**CALVERT CLIFFS NUCLEAR POWER PLANT**

**ESFAS 12 ALARM MANUAL**

# RO Question #31 (ID Q50290)

# Licensee's Justification for Change

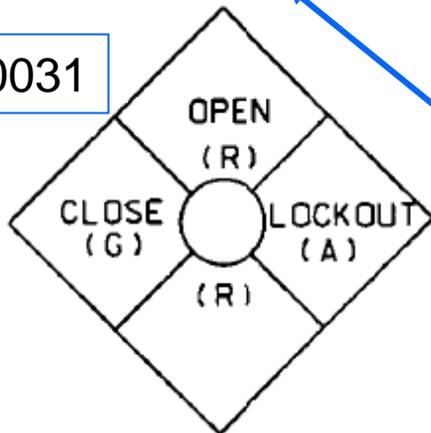
If 1HS3659A position is selected to On the following contact configuration will occur:

- 3-4 closed and maintained
- 7-8 closed and maintained
- 11-12 closed and maintained

Maintained contacts will remain in their respective configurations once 1HS3659A is selected to ON.

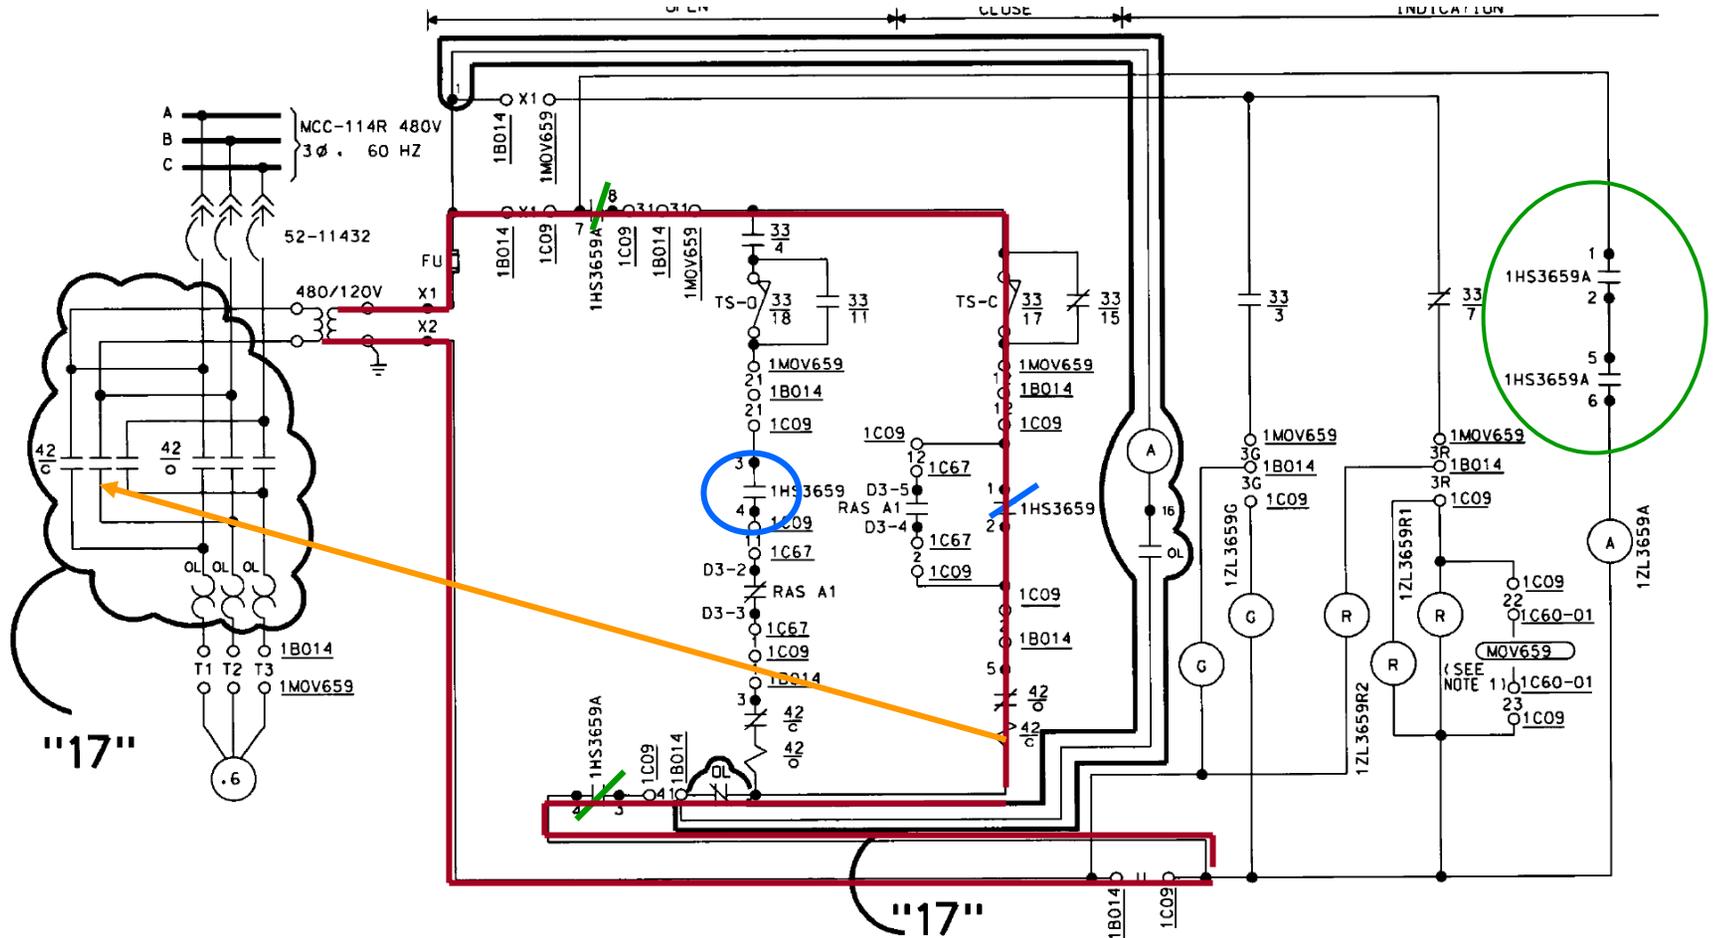
The next slide will display the associated control switches and contact schemes for:

- SI PP Recirc Lockout handswitch 1HS3659A
- SI Recirc PPS MOV 659 handswitch 1HS3659
- Both handswitch contact schemes are maintained following handswitch re-positioning.

61075SH0031

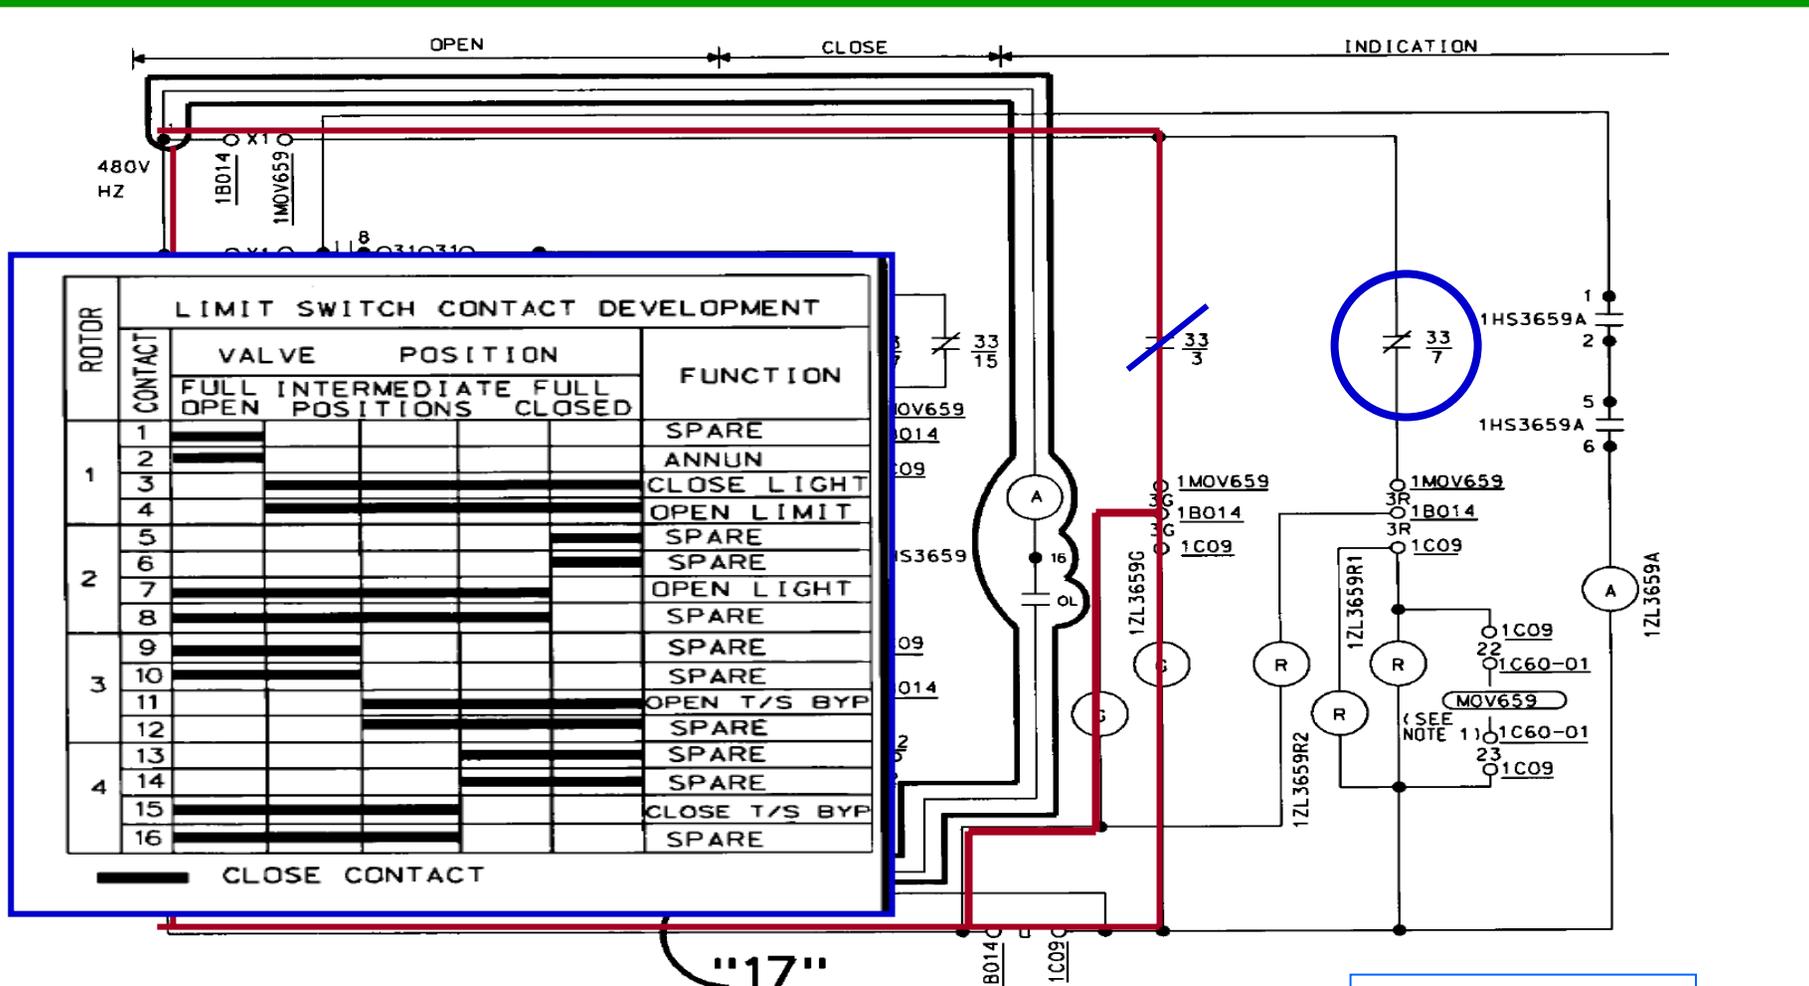
The next slide will display SI Recirc PPS MOV 1MOV659 valve position indication contact scheme during its travel to the closed position.

- The **redline** traces the flow path for closed indication.
- Contact **33/3** (rotor one contact 3) will close when 1MOV659 is 80% open
- Contact **33/7** (rotor 2 contact 7) will open when 1MOV659 is 80% closed.

SCHEME 1B14 32  
 VALVE SHOWN IN FULL OPEN POSITION  
 FACILITY ZA

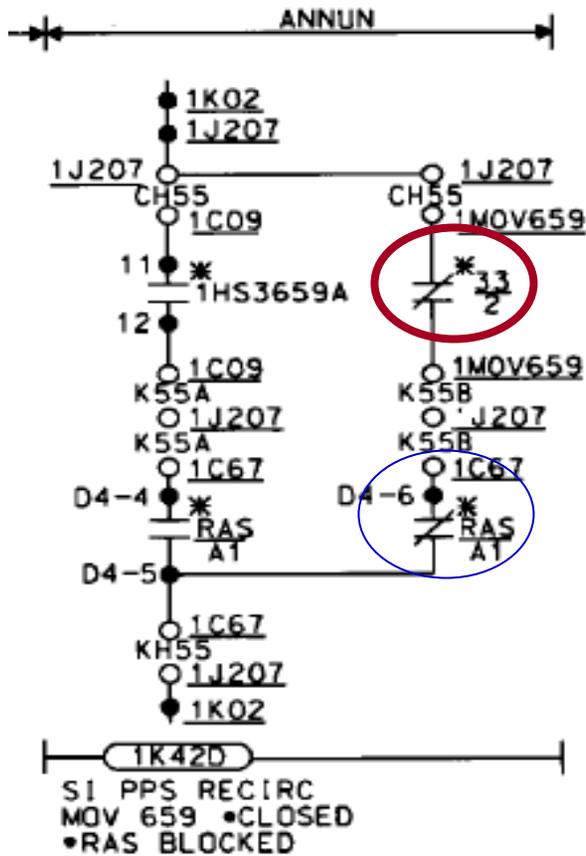
Recall that the **“SI PPS RECIRC MOV 659 CLOSED RAS BLOCKED”** alarm will actuate when the logic for the following initiating devices are satisfied:

- 1MOV-659 position
- 1-HS-3659A (SI PP RECIRC LOCKOUT) handswitch position
- RAS

61075SH0031

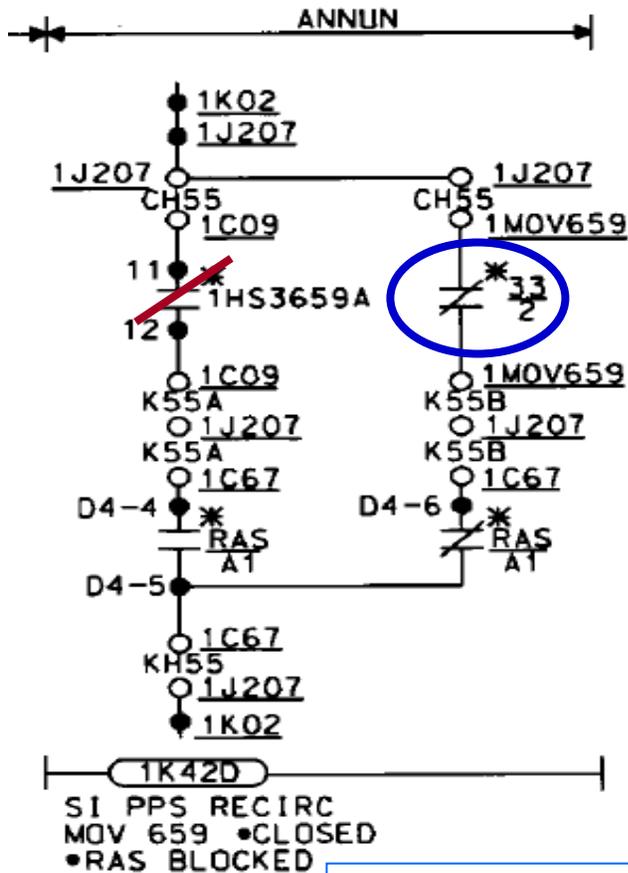
Recall if **SI PP Recirc Lockout handswitch 1HS3659A** is selected to ON, contacts **11-12** will close. If **SI Recirc PPS MOV 659** handswitch 1HS3659 is selected to close with 1HS3659A in ON the valve will travel shut. As the valve travels shut contact **33/2** (rotor one, contact 2) will open when the valve is 80% open. When contact **33/2** opens without a RAS actuation the alarm circuit will de-energize and actuate the **SI PPS RECIRC MOV 659 CLOSED RAS BLOCKED** alarm

RO question selection D “MINI FLOW RETURN TO RWT ISOL, 1-SI-659-MOV shut and SI PP RECIR LOCKOUT handswitch, 1-HS-3659A in ON” satisfies the condition of the second bulleted item per the 1C09 alarm manual and electrical print 61076SH0031.
